Work Order ID 56967

Item Name: Webbing (Short Basket)

DRAWING NO.
 D4029

TITLE
 WEBBING, 350 BASKET

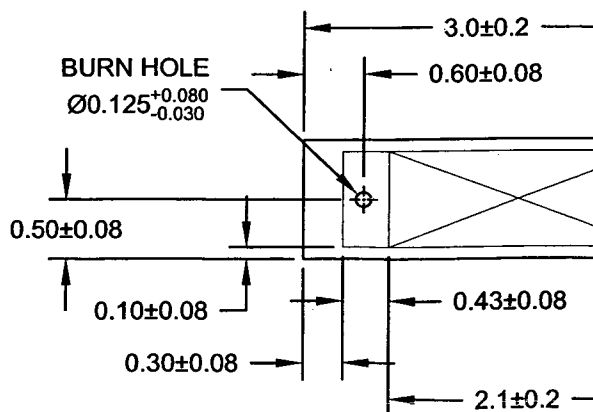
NCR: 56967		WORK ORDER NON-CONFORMANCE (NCR)						
DATE	STEP	Description of NC Section A	Corrective Action Section B			Verification Section C	Approval Chief Eng	Approval QC Inspector
			Initial Chief Eng	Action Description Chief Eng	Sign & Date			
10/03/29	120	Punching inspection found that the webbing is too long. measuring 63.25". should be 62.5 ± .25" R.C. made incorrectly at Aerokey. Lack of attention.	<i>[Signature]</i> Lesum	- inform Aerokey Aerokey and return for correctly made Part. WCAH Supplier RHAH <i>3 M/A</i>	<i>[Signature]</i> 10/3/29	<i>[Signature]</i> 10/05/07	<i>[Signature]</i> Lesum	<i>[Signature]</i> 10/03/29

Please send the nets back, we will try our best to make the length shorter by 0.75". But first can you ask the engineer if the 0.75" difference is ok? That way we can save the trouble of sending it back and forth.

****It is very tough for us to get the exact length as the drawing as the net shrinks and varies, when we sew the inside 1" cross boxes****

Part No: D4029-043 PAR #: _____ Fault Category: Supplier NCR: Yes No DQA: _____ Date: 10/05/06
 Resolution: Scrap Disposition: return to supplier QA: N/C Closed: _____ Date: 10/05/07
